Comments on “Low-Latency Digit-Serial Systolic Double Basis Multiplier over $GF(2^m)$ Using Subquadratic Toeplitz Matrix-Vector Product Approach”

Abstract—The digit-serial systolic double basis multiplier architecture proposed in the above paper does not generate the correct multiplication results as it requires more latches to process digits of inputs in appropriate clock cycles. In this comment, we present the corrected architecture and obtain its time and area complexities. More importantly, we show that the claims made by the authors regarding having significantly lower time and area complexities than its counterpart are not valid.

Fig. 1. (a) The original digit-serial systolic multiplier architecture, (b) its processing element [1].

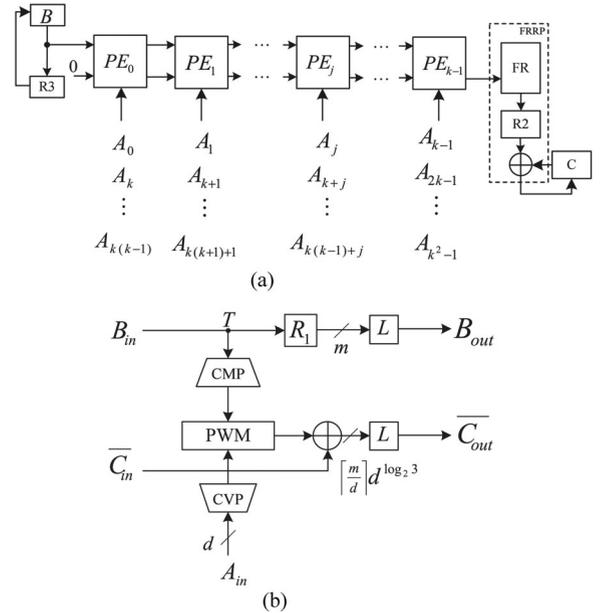
which is computed by Algorithm 2 of [1]. The digit-serial systolic double basis multiplier over $GF(2^m)$ proposed in [1] is shown in Fig. 1a. In this figure, the register B initializes with the coordinates of the field element B , the $R3$ module uses to update the register B with $Bx^{dk} \bmod F(x)$ in each clock cycle. The $R2$ module performs $C_i \bmod (x^m + 1)$. The processing element (PE) of this architecture (Fig. 1b) implements the subquadratic Toeplitz matrix-vector product (TMVP) approach proposed in [2]. In Fig. 1b, the R_1 module performs the computation of $B_{in}x^d \bmod F(x)$ which appears in the output of the m -bit latch L after each cycle.

If one removes all latches in Fig. 1b from all k PEs, then Fig. 1a correctly computes (1) in k clock cycles. This scheme has a long propagation delay. To reduce the propagation delay, the authors of [1] have added latches at the outputs of PEs as shown in Fig. 1b. However, they missed to add latches in the $A_i, 0 \leq i \leq k-1$, input of all k PEs. Specifically, we propose the following to correct the architecture of Fig. 1a proposed in [1].

The number of d -bit latches added to the original architecture of Fig. 1a is $1 + 2 + \dots + k - 1 = k(k-1)/2$. Thus, the total number of 1-bit latches becomes $0.5k(k-1)d + (k+2)m + kS_3$ using the complexities presented in [1]. Also, no multiplexers (MUXs) are reported for the multiplier architecture of Fig. 1. It is noted that m number of 2:1 MUXs are required to initialize the register B with the coordinates of the field element B . Moreover, the time delay of an AND gate (T_A) is missing in the propagation delay. As a result,

Proposition 1. To obtain the corrected architecture and hence to compute (1) correctly, one needs to add $i, 1 \leq i \leq k-1$, d -bit latches between A_i and the input of PE_i in the architecture of Fig. 1a.

Proof. At the beginning of computation, the input of PE_0 in Fig. 1a is B . Then, the output of the m -bit latches of PE_0 generates BA_0 after the first clock cycle. To reach A_1 to the PE_1 after one clock cycle, i.e., at the same time the output of PE_0 generates BA_0 , a d -bit latch should be inserted between A_1 and the input of PE_1 . Thus, the output of PE_1 generates $B(A_0 + A_1x^d)$ after two clock cycles. Similarly, to add BA_2x^{2d} to $B(A_0 + A_1x^d)$ and appear it at the output of PE_2 , one needs to make two clock cycles delay for A_2 . To implement two clock cycles delay, one needs to insert two blocks of d -bit latches between A_2 and the input of PE_2 . Then, A_2 reaches PE_2 at the time $B(A_0 + A_1x^d)$ available at the input of PE_2 and hence the output of PE_2 generates $B(A_0 + A_1x^d + A_2x^{2d})$ after three clock cycles. Therefore, by adding $k-1$ blocks of d -bit latches at the input A_{k-1} of PE_{k-1} , the output of PE_{k-1} generates $B(A_0 + A_1x^d + A_2x^{2d} + \dots + A_{k-1}x^{(k-1)d})$ after k clock cycles. Since after the first clock cycle the input of PE_0 becomes $Bx^{dk} \bmod F(x)$, one can verify that the output of PE_{k-1} becomes $Bx^{dk}(A_k + A_{k+1}x^d + A_{k+2}x^{2d} + \dots + A_{2k-1}x^{(k-1)d}) \bmod F(x)$ after $k+1$ clock cycles. Similarly after $k+i$ clock cycles for $1 \leq i \leq k-1$, the output of PE_{k-1} computes $Bx^{idk}(A_{ik} + A_{ik+1}x^d + A_{ik+2}x^{2d} + \dots + A_{ik-1}x^{(k-1)d}) \bmod F(x)$. Therefore, the corrected architecture computes (1) after $2k$ clock cycles. \square
